Modifications Notices

Issue Date
October 15, 2026

20261009_PDC_00002

Notice of change in outer plating due to improvement of parts procurement

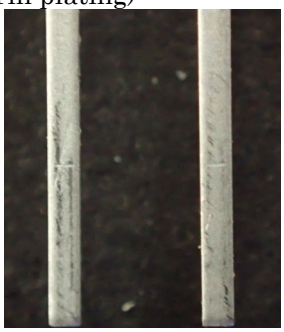
Before the change	After the change
The outer plating of the light emitting/receiving terminals will be changed. Ag plating (Silver plating)  Figure. Ag-plated terminals' color (typical example)	Sn plating (Tin plating)  Figure. Sn-plated terminals' color (typical example) No changes in soldering temperature and dimensions.
